7 INSTRUMENTATION AND CONTROLS

This chapter of the final safety evaluation report (FSER) documents the U.S. Nuclear Regulatory Commission (NRC) staff's (hereinafter referred to as the staff) review of Chapter 7, "Instrumentation and Controls," of the NuScale Power, LLC (hereinafter referred to as the applicant), Design Certification Application (DCA), Part 2, "Final Safety Analysis Report." The staff's regulatory findings documented in this report are based on Revision 5 of the DCA, dated July 29, 2020 (Agencywide Document Access and Management System (ADAMS), Accession No. ML20225A071). The precise parameter values, as reviewed by the staff in this safety evaluation, are provided by the applicant in the DCA using the English system of measure. Where appropriate, the NRC staff converted these values for presentation in this safety evaluation to the International System (SI) units of measure based on the NRC's standard convention. In these cases, the SI converted value is approximate and is presented first, followed by the applicant-provided parameter value in English units within parentheses. If only one value appears in either SI or English units, it is directly quoted from the D

Figure 7.2.7-1: Setpoint relationships during surveillance testing and calibration⁴

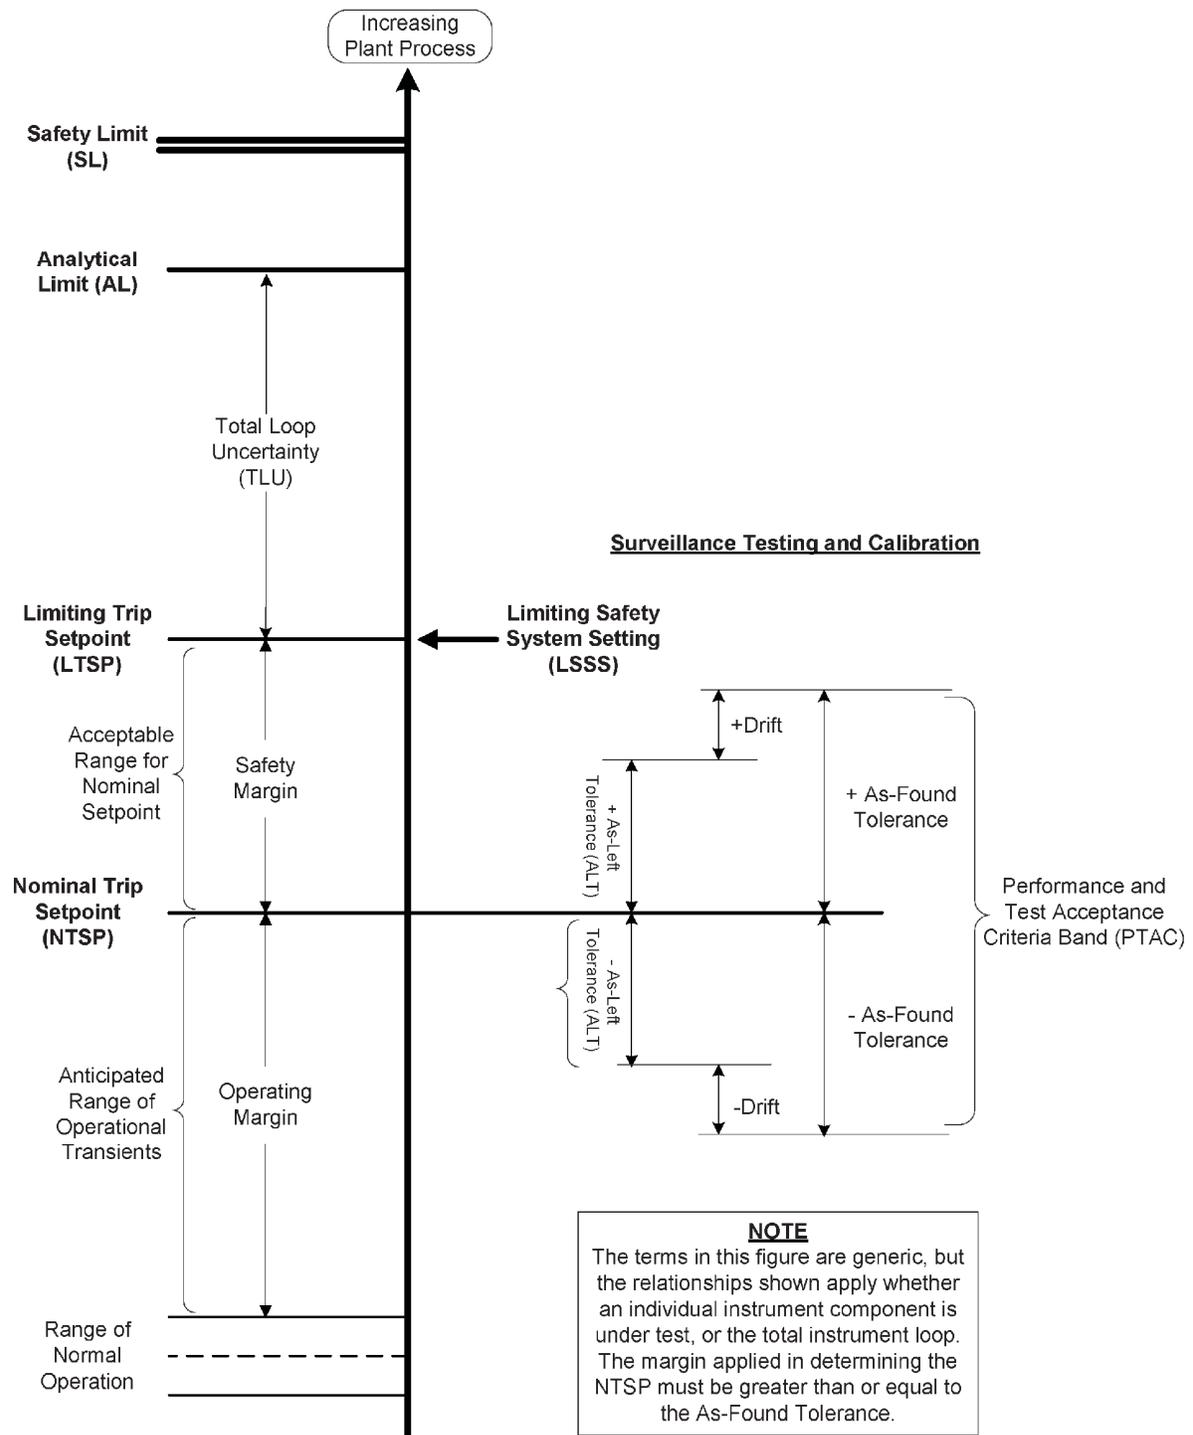
This figure is intended to provide relative position and not to imply direction. Sections 4.1.3 and 4.1.4 in TeR-0616-49121 define LTSP as an LSSS and also define NTSP as the desired value of
